INTERNAL MEMORANDUM

Application No: 23/P/1439/OUT

Proposal: Outline application for the erection of up to 75 dwellings and associated works, with access for approval; all other matters of appearance, layout, scale and landscaping reserved for subsequent approval

Date: 22/01/2024

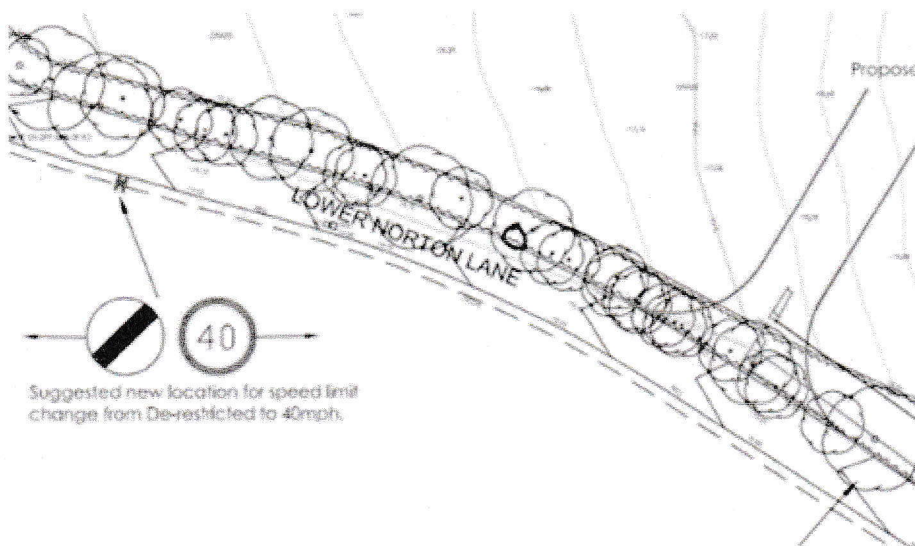
Proposals indicate that a new access is to be formed to the north side of Lower Norton Lane. It should be noted that Lower Norton Lane in this location is subject to the national speed limit, although proposals indicate that the existing 40mph zone would be extended to include the proposed access. The Highway Authority would consider that the proposal to relocate the 40mph should be relocated closer to the proposed access junction and be located on the northern side of the carriageway so that vehicles approaching from Kewstoke have the change of speed limit signs on their side of the road, approximate location in blue below:

A TRO would be required to deliver these changes and as such £3,600 would be required to be delivered **via section 106 agreement**. A speed roundel on the carriageway surface should also be incorporated into the design and delivered via S278 agreement.
